Response to Public Comments  
Phase II & III Reports  
*Former Raytheon Facility*  
*430 Boston Post Road*  
*Wayland, Massachusetts*

24 December 2001

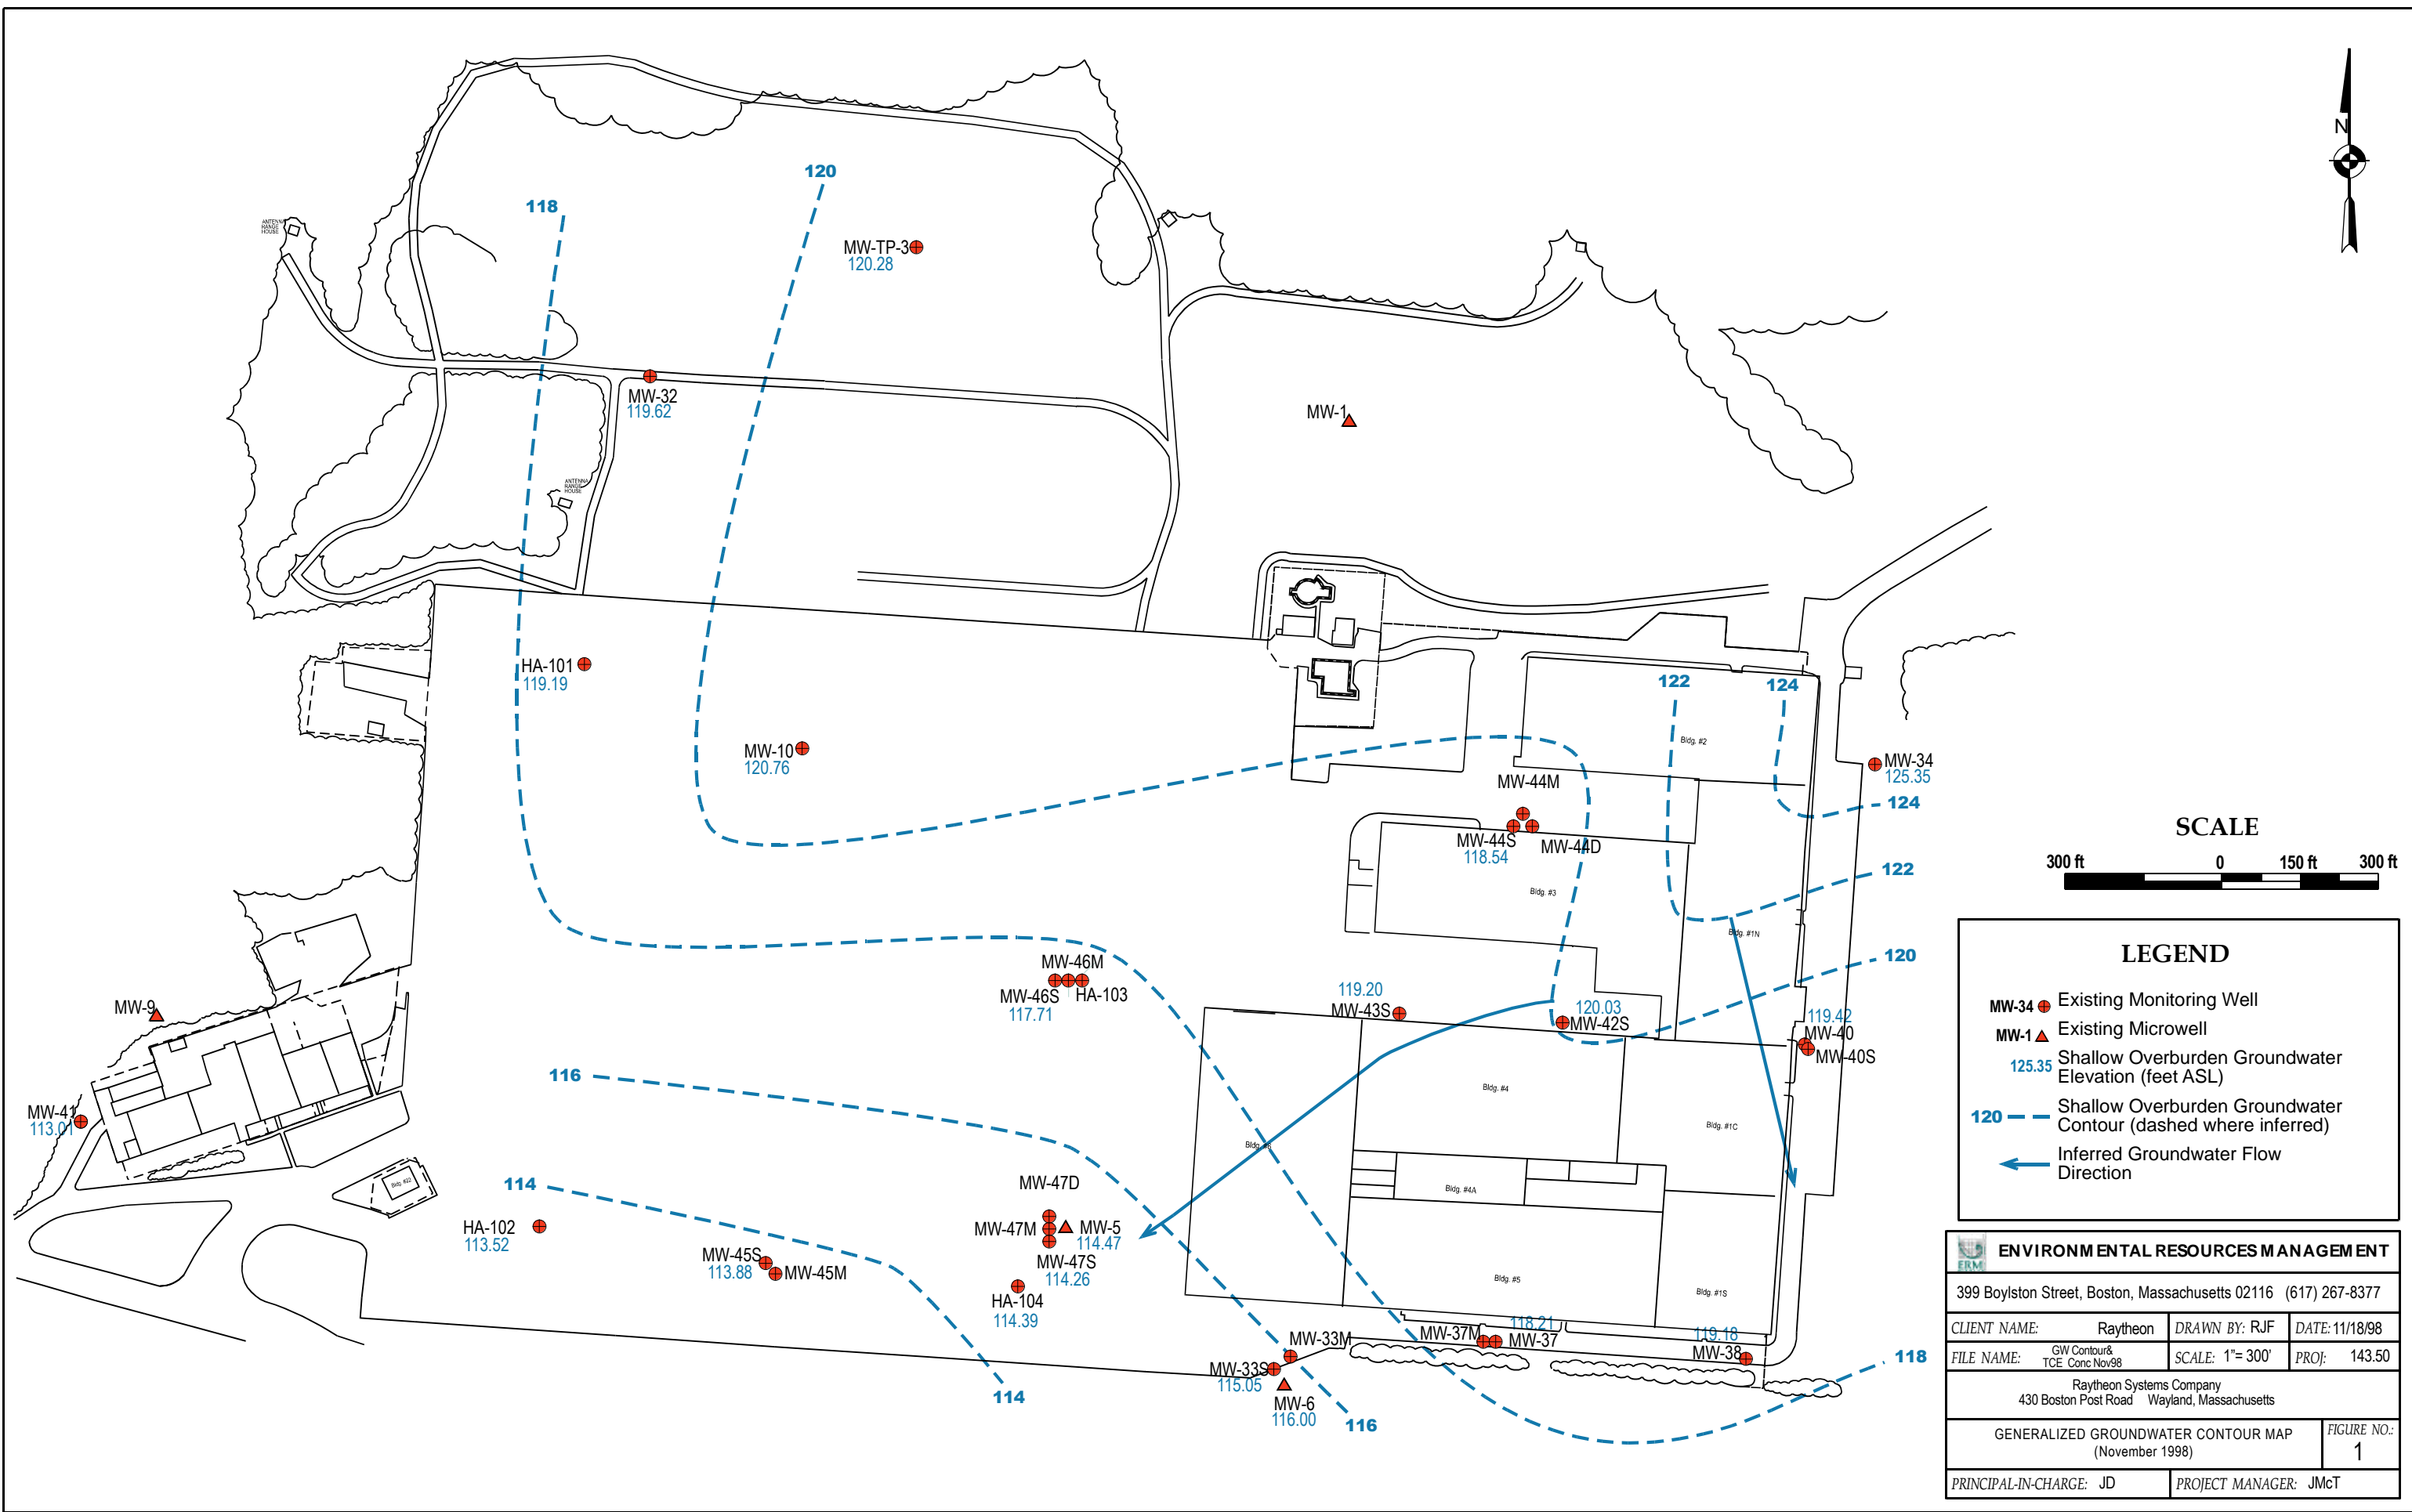
*5) I do not understand why the latest reports do not show complete groundwater contouring, particularly knowing that the drinking water wells of concern are located only a half-mile north. Groundwater contour lines for this site appear to stop at the western edge of the existing asphalted parking lot. At the PIP meeting we were told groundwater flows south and southwest, even in the wetlands at the western part of the site near the Sudbury River, which flows northward. My review of the groundwater contour lines shows them turning northward just at the edge of the parking lot. Why would scientists stop drawing groundwater contours at an artificial (parking lot) boundary? Groundwater contouring also needs to be determined by data collected in multiple seasons, particularly in drier periods than what was sampled to reflect actual drawdown and flow in the area between the Baldwin Well Field and the contaminated wetland.*

*9) State the month and year when data for ground flow directions was obtained. In order to adequately assess the groundwater flow direction in this area, data should be representative of the four seasons.*

ERM appreciates your comment identifying this issue and have included additional groundwater contour maps depicting seasonal variations in groundwater flow patterns beneath the Site. Figure 12 was intended to summarize groundwater flow patterns beneath the Site using the most recent data. As discussed in the response to comment 1b, ERM has presented a significant amount of additional groundwater elevation data in Table 5 of the Phase II report. Additional contour maps displaying seasonal variations in the direction of groundwater flow are provided in Attachment A. With minor seasonal variations noted, these maps indicate flow directions similar to Figure 12.

Please refer to the dates for groundwater gauging events listed in Table 5, Summary of Groundwater Gauging Data in the Phase II Report.

LEGEND	
MW-9D	Monitoring Well
240	TCE Concentration (mg/l)
--- (dashed blue)	Shallow Overburden Groundwater Table
--- (dashed green)	TCE Conc. > 5 mg/L

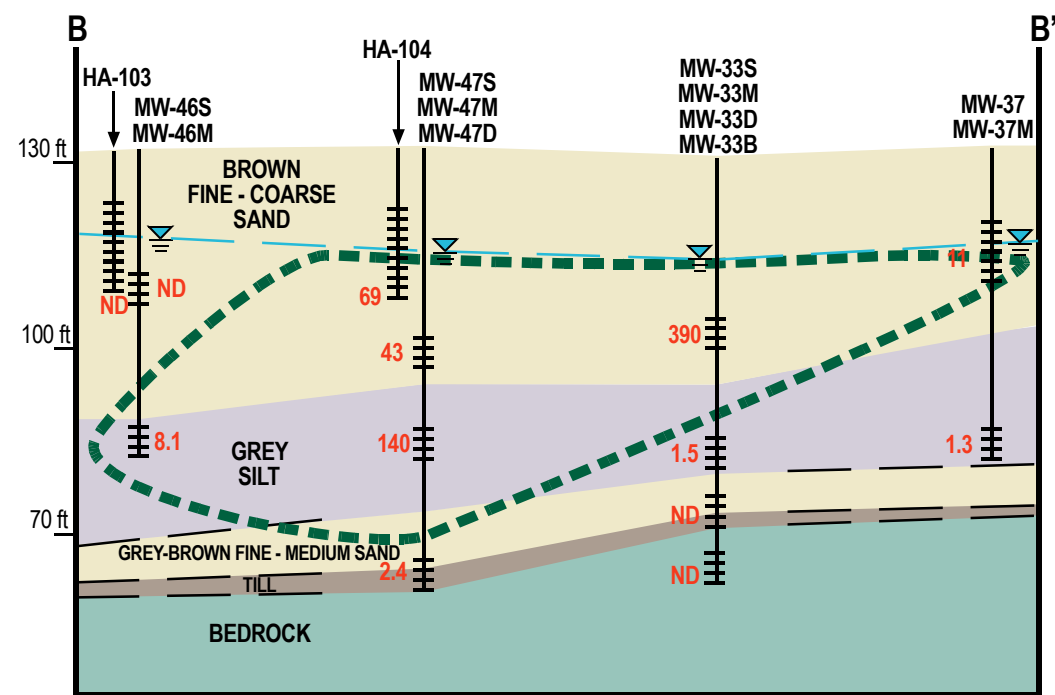
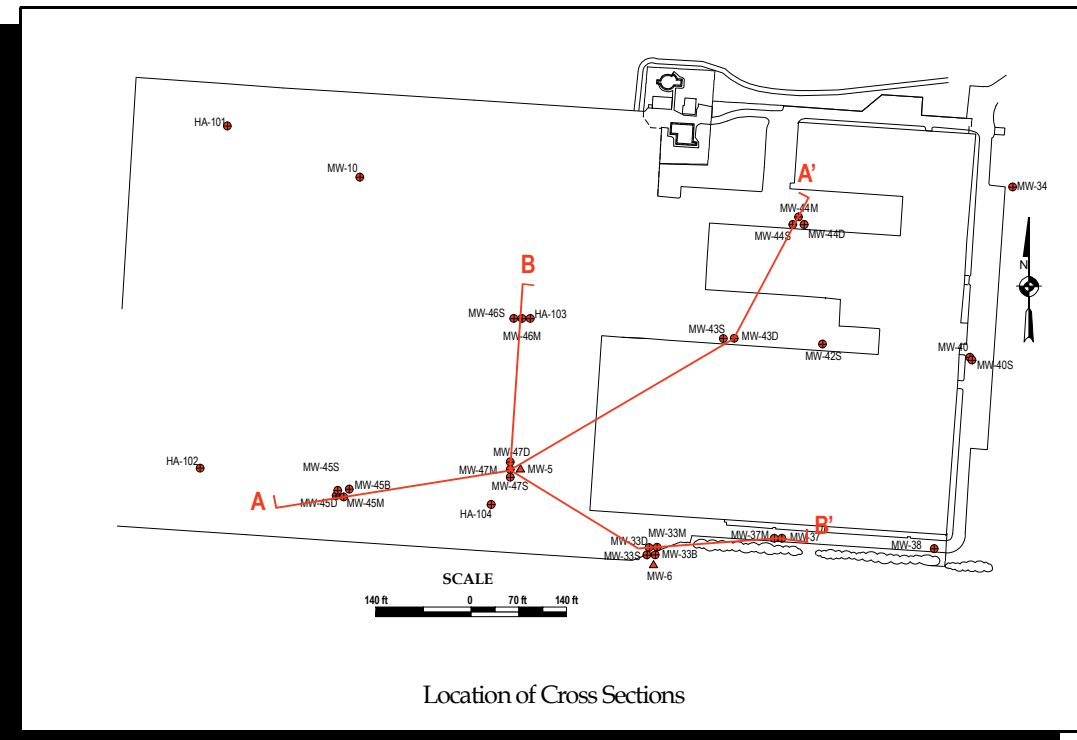
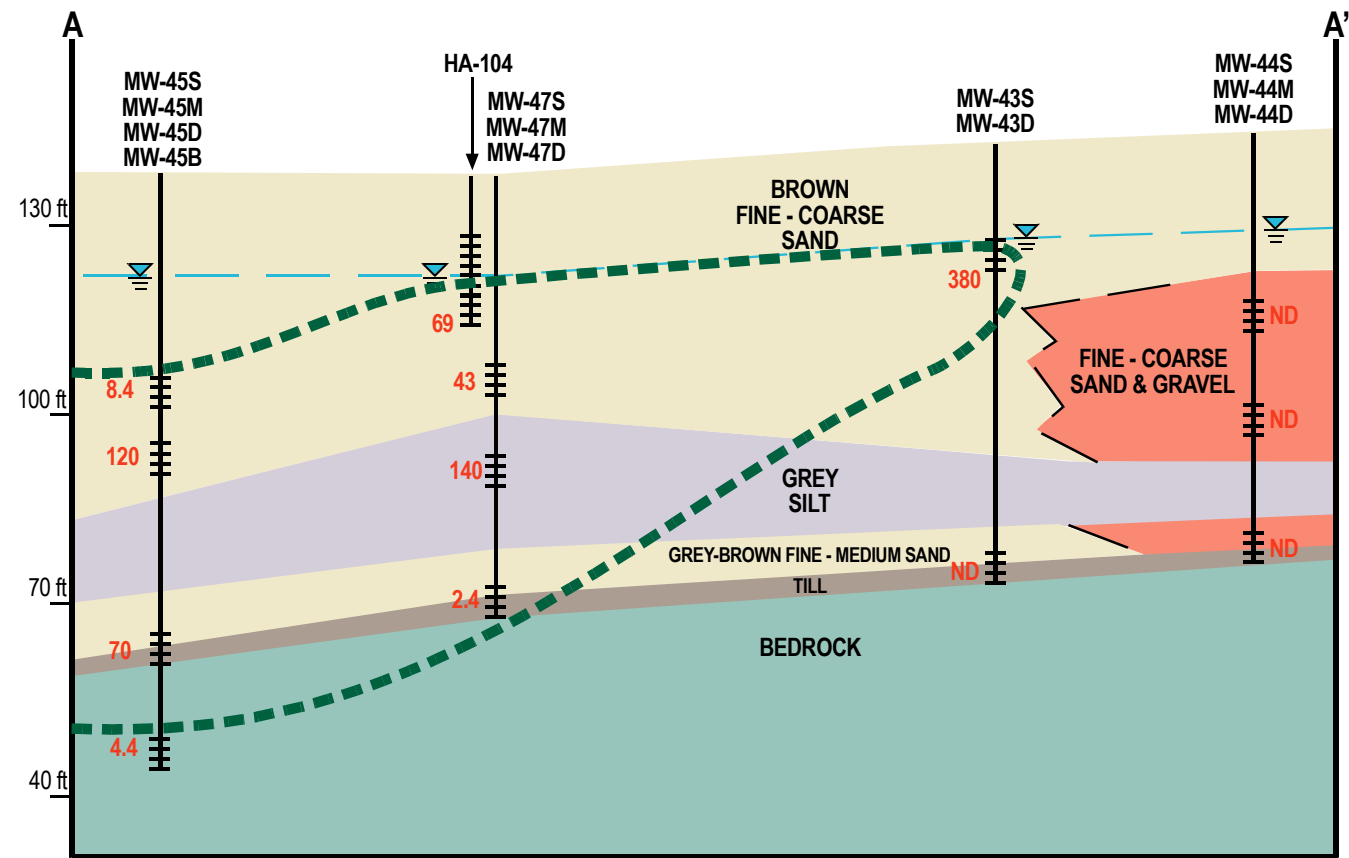
*1f. The three-dimensional extent of the TCE plume is not completely defined. The completeness of the 5 ppb TCE contour shown in Figure 16 of the Phase II report for cross section A-A' is not substantiated by the data shown, since there are no downgradient wells screened at a depth of about 45 feet below surface grade (corresponds to the highest TCE value, 120 ppb, detected in well MW-45M). Additional groundwater data at several depths are needed to definitively represent the three-dimensional extent of the TCE plume for this and other cross sections shown.*

We appreciate your comments regarding this figure and have implemented the following modifications to clarify our interpretations. ERM has modified Figure 16 to indicate an open contour to show that TCE concentrations in groundwater extend downgradient (south/southwest) of the existing monitoring well network in response to this comment (see attached Figure 16 in Attachment A). These modifications will be incorporated into the final Phase II Report by submittal of an amendment.
